**GEOTECHNICAL REVIEW
OF THE STATUTORY ENVIRONMENTAL
ASSESSMENT (EA) FOR
VACHERIE SALT DOME SITE
WEBSTER AND BIENVILLE
PARISHES, LOUISIANA**

DRAFT FINAL REPORT

**LOUISIANA DEPARTMENT
OF ENVIRONMENTAL QUALITY**

FRANCIS S. KENDORSKI, P.E.

Figure 4.1-2. Line ELV-S2. Adapted from Ertec (1984, ONWI-520, Fig. 4-5).

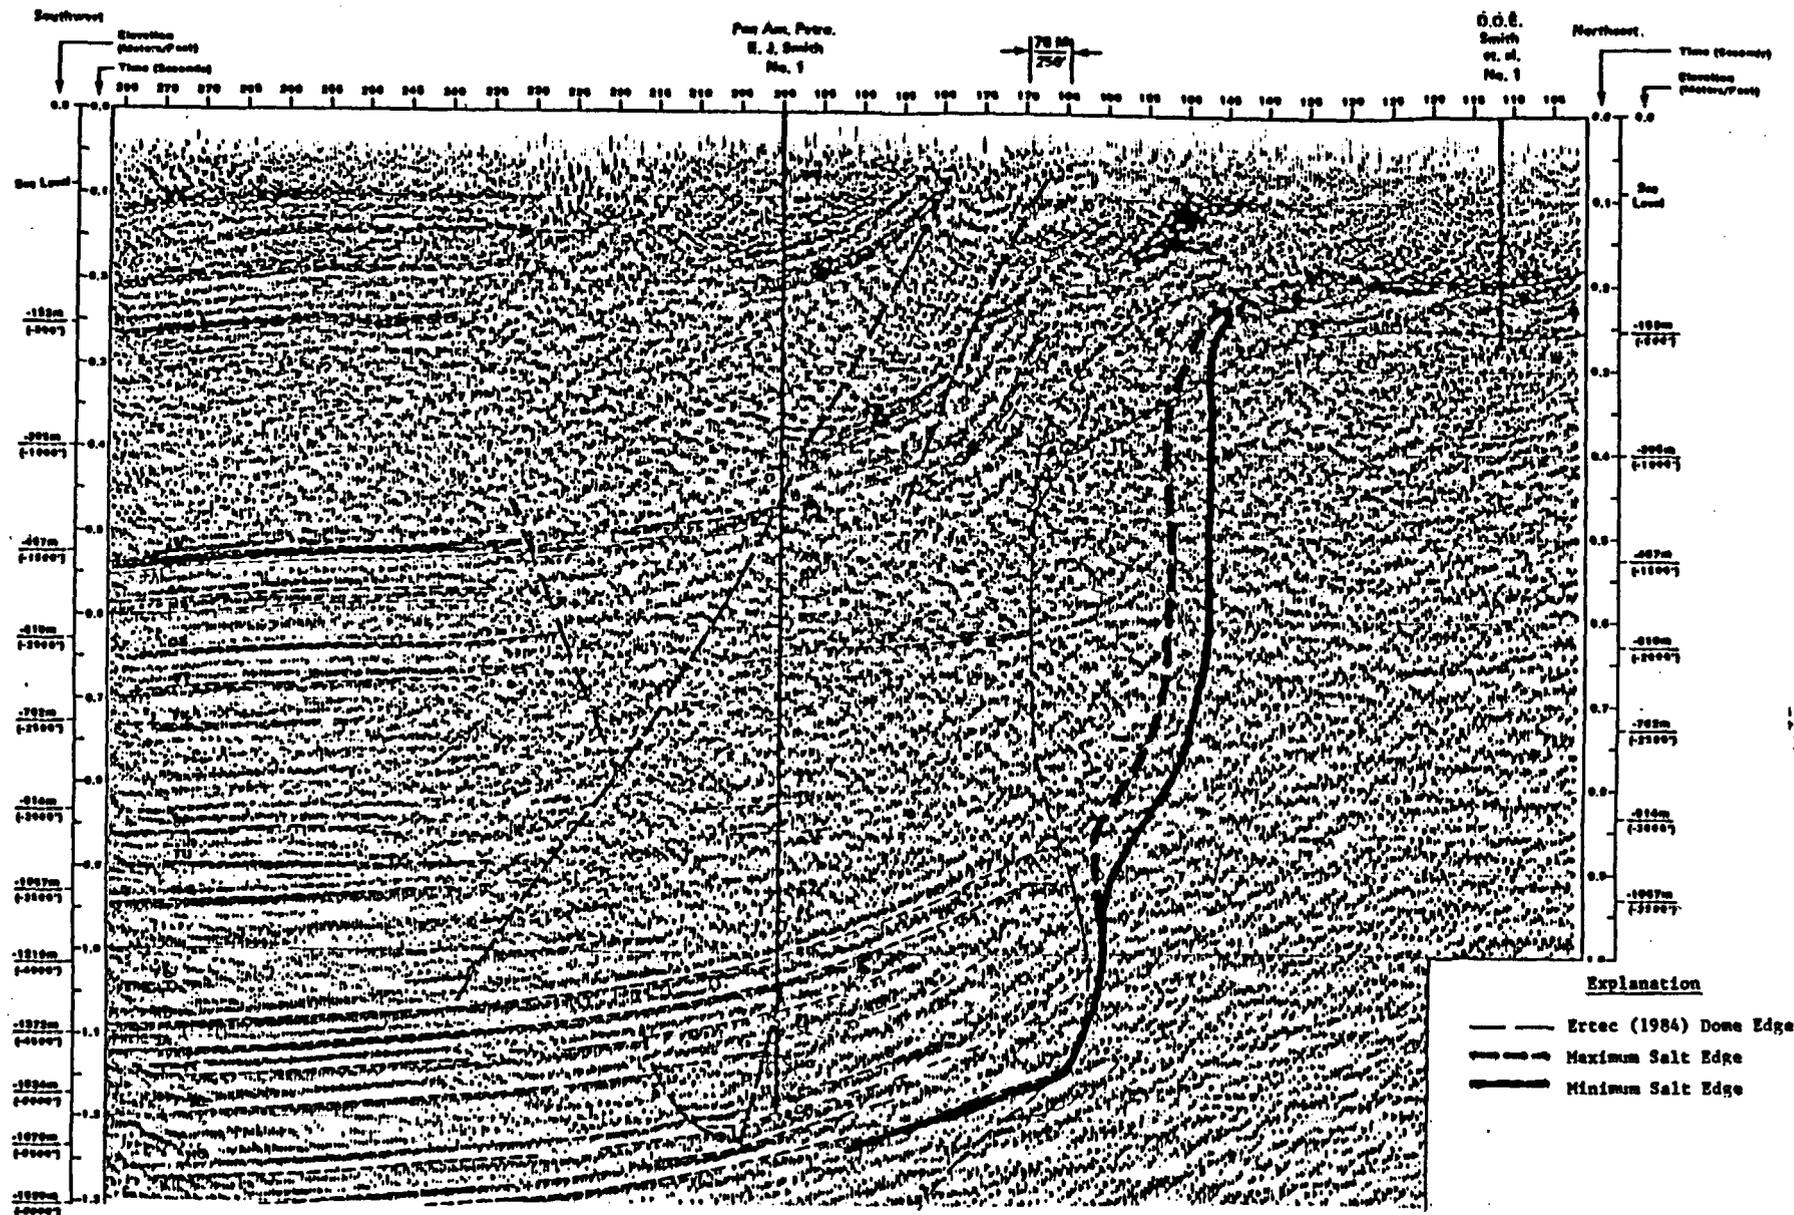
The Ertec interpretations of domal area are much higher than those interpreted in this report. Total available area at -3,000-ft MSL ranges between 910 and 1,280 acres, excluding the 800-ft buffer zone. These estimates of available domal area are far below the 1,500 acre minimum used by ONWI (1982, ONWI-109, p. 41) to eliminate salt domes from consideration for nuclear waste

Figure 4.7-1 - Flow Chart of the Site Screening Process

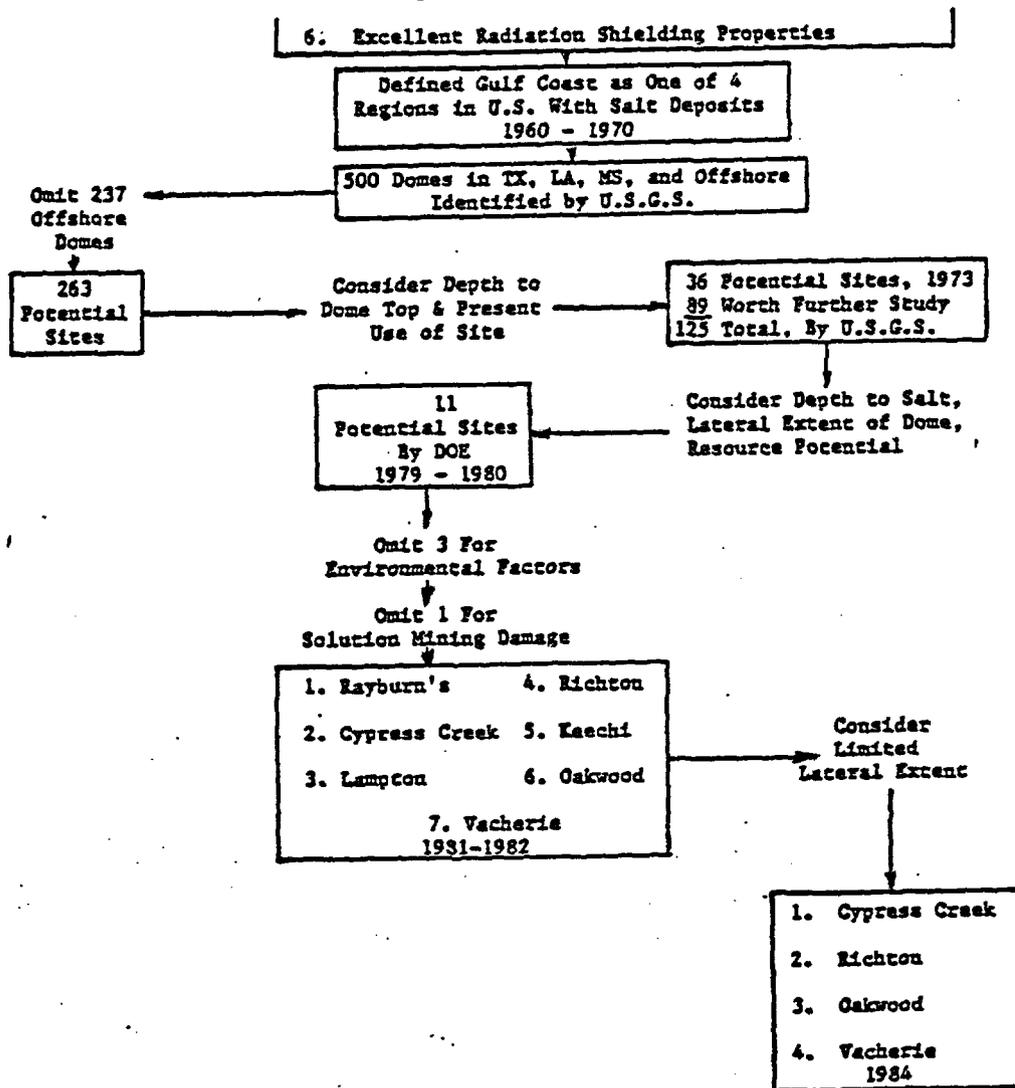
Figure 4.7-1 illustrates the screening history. However, the execution of the site screening process has not been consistent. Screening has included some arbitrary decisions, that is, equal application of siting criteria has not been applied equally to all sites.

Vacherie is still included as a potential site despite its limited lateral extent, justified by a proposed multi-level repository. This "solution" should then requalify other sites that were eliminated from consideration because of limited lateral extent. The NWPA does not exclude site re-evaluation based on changing siting criteria.
